SUBDIVISION REVIEW SHEET

CASE NO.: C8-2018-0032.0A**Z.A.P. DATE:** March 19, 2019**SUBDIVISION NAME:** West Courtyard Subdivision**AREA:** 3.267 acres**LOT(S):** 2**OWNER/APPLICANT:** Richard A. Engel**AGENT:** Perales Engineering, LLC
(Jerry Perales)**ADDRESS OF SUBDIVISION:** 6910 West Courtyard Drive**GRIDS:** MF - 30**COUNTY:** Travis**WATERSHED:** Bull Creek**JURISDICTION:** Full Purpose**EXISTING ZONING:** I-RR**DISTRICT:** 10**PROPOSED LAND USE:** Residential**SIDEWALKS:** Sidewalks will be provided along West Courtyard Drive and Finklea Cove.**VARIANCE REQUEST:** From LDC 25-8-301(A) prohibiting construction of a driveway on slopes greater than 15 percent, unless to provide primary access to an area of at least 2 contiguous acres with a slope of less than 15 percent, or at least five residential units. (SEE ATTACHED EXHIBIT A)**DEPARTMENT COMMENTS:** The request is for approval of the variance from LDC 25-8-301(A) listed above and a subdivision, namely, West Courtyard Subdivision. The proposed plat is composed of 2 lots on 3.267 acres.

ENVIRONMENTAL COMMISSION MOTION 20190206 008b**Date:** February 6, 2019**Subject:** Courtyard Final Plat and Subdivision (W/R C8-2017-0016

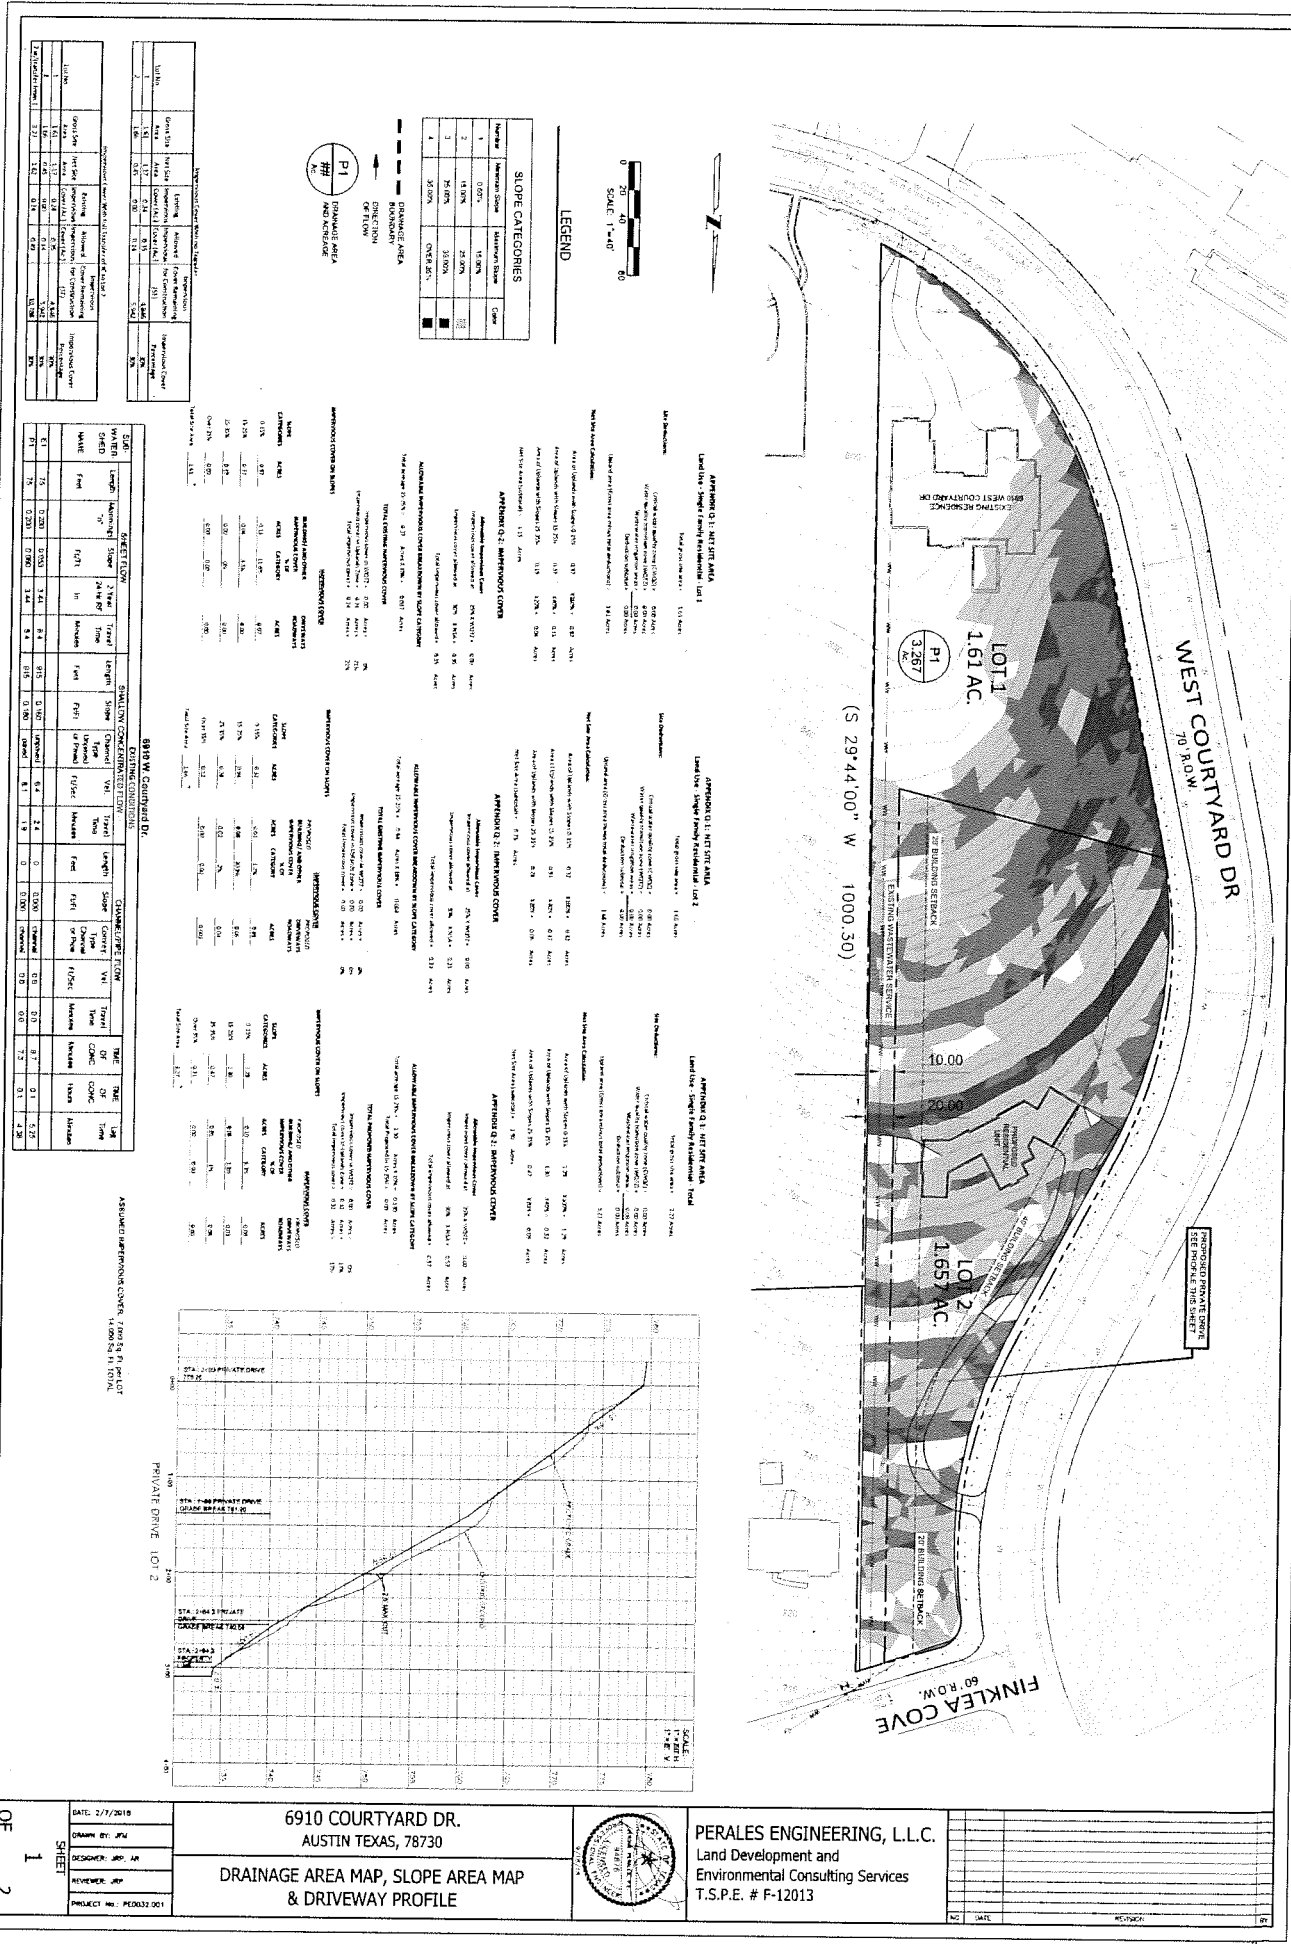
Although the proposed Lot 2 has a number of steep slopes, as shown on the slope map, it has sites suitable for development with a single-family home. The slope map shows the proposed location of a single-family home and driveway off of West Courtyard. The single-family home

structure can be built without any variances from Chapter 25-8 of the Land Development Code. The proposed driveway, however, would cross slopes in excess of 15% and accordingly would require a variance from Section 25-8-301 of the LDC.

The site can be developed with a single-family home and the required parking without an environmental variance, although such a configuration would be highly undesirable. The attached diagram shows an illustrative layout of one allowable alternative. This layout would allow construction of the home in the same location proposed by the owner, but would locate the parking at the base of a slope away from the house. The proposed alternative parking area would be connected to the house by a walkway traversing 40 vertical feet by 280 horizontal feet, requiring around 80 steps. Such a configuration—while permitted by the Code—would impose a patent hardship on the property owner. The proposed findings of fact set forth the justification for the variance in more detail.
